PRODUCT REFERENCE BOOK

for the Tektronix Type

422

oscilloscopes

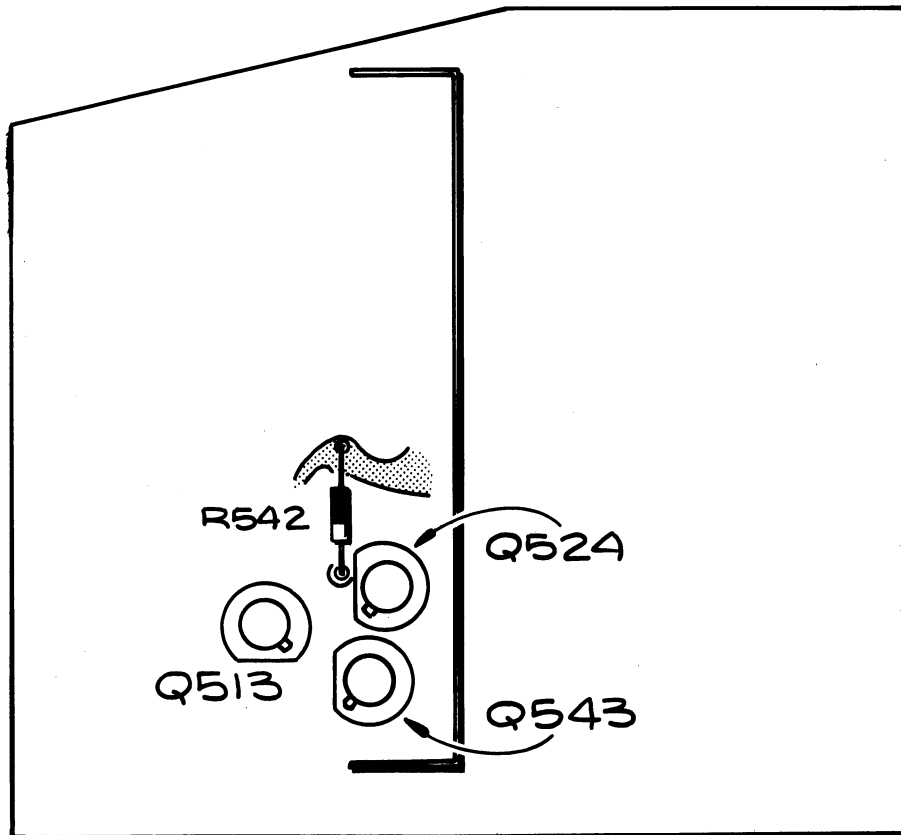
Replace R542 with a 5.1Ω wirewound resistor (308-0417-00). Refer to the illustration for the proper location.
